AMENDMENT NO. 2 (August 11, 2017)

AIS-100

**Requirements for the Protection of Pedestrian and other Vulnerable
Road Users in the event of a Collision with a Motor Vehicle**

AMENDMENT NO. 1 15 December 2015

Figure 6A

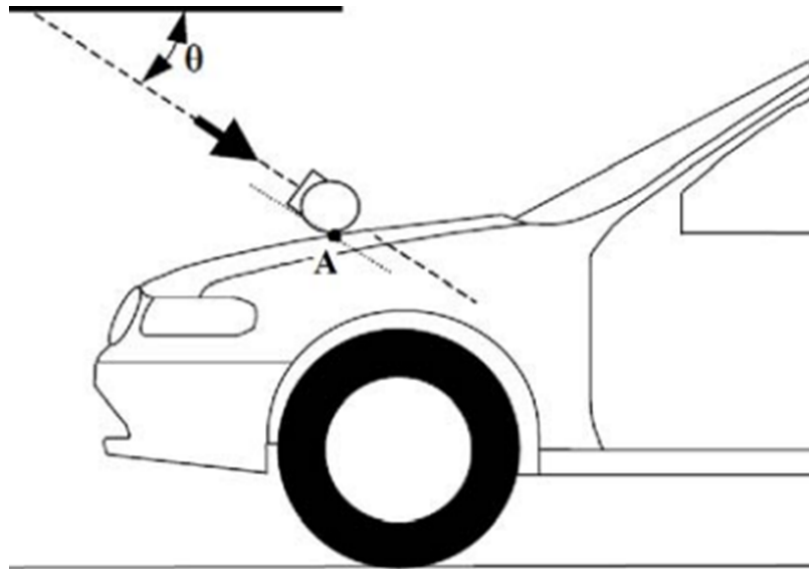
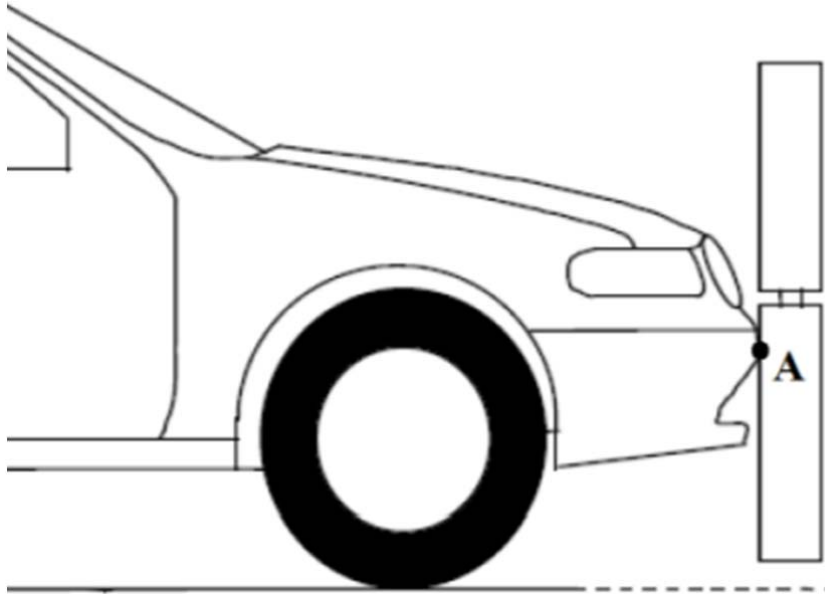
Delete "Figure 6", "Impact point and Target Point" and add new "Figure 6A" and "Figure 6B" as below:

Measuring point (as referred in clause 3.31.1.)

Measuring point (as referred in clause 3.31.2.)

Figure 7

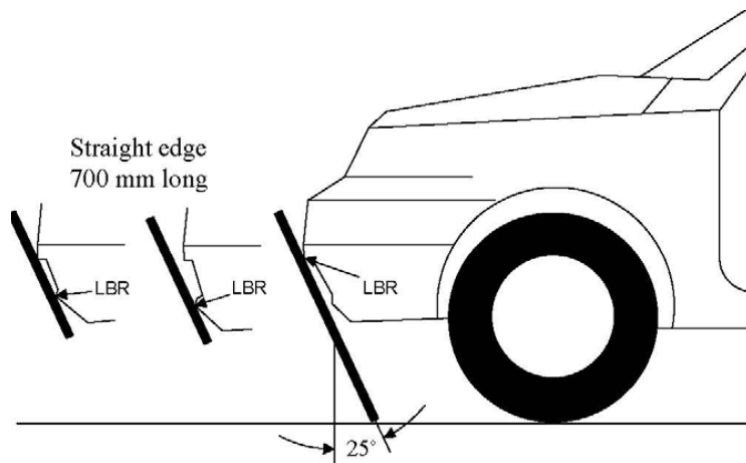
In Figure 7, Add text “(LBRL)” next to the figure title as below:

Lower Bumper Reference Line (LBRL)

Figure 9
Upper Bumper Reference Line (UBRL)

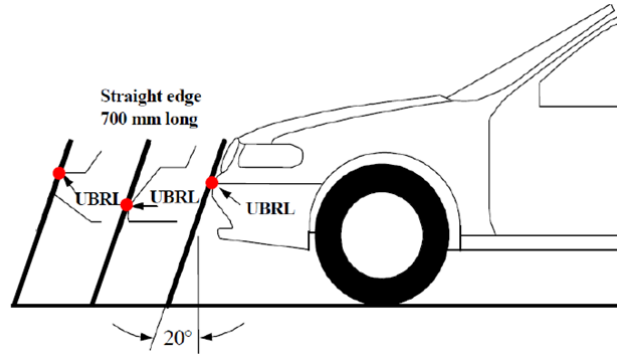
Substitute following Figure and figure title for existing Figure 9.

3.25 **"Upper bumper reference line"** means a line which identifies the upper limit to significant points of pedestrian contact with the bumper. It is defined as the geometric trace of the uppermost points of contact between a straight edge 700 mm long and the bumper, when the straight edge, held parallel to the vertical longitudinal plane of the car and inclined rearwards by 20° to the vertical, is traversed across the front of the car, while maintaining contact with the ground and with the surface of the bumper (see Figure 9).

Where necessary the straight edge shall be shortened to avoid any contact with structures above the bumper.

Figure 26:
Corner reference point (as referred in clause 3.32)

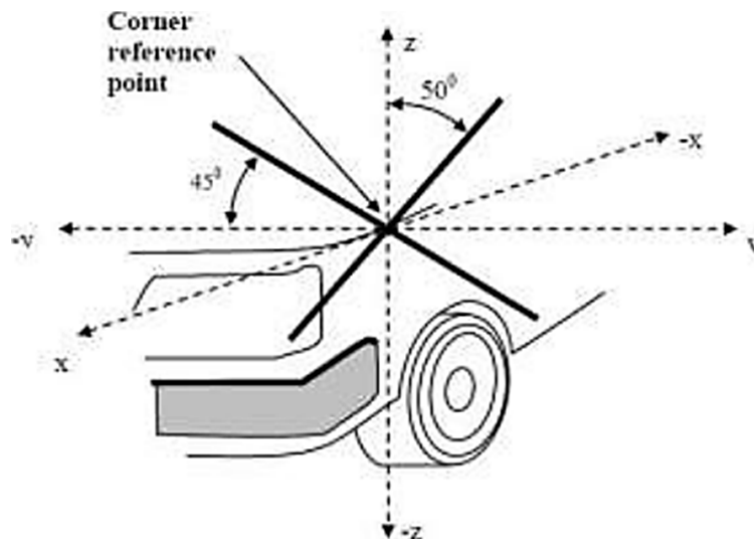
Add new “Figure 26” just below the existing Figure 9.

- 3.32. "Corner reference point" means the intersection of the bonnet leading edge reference line and of the bonnet side reference line (see Figure 26).
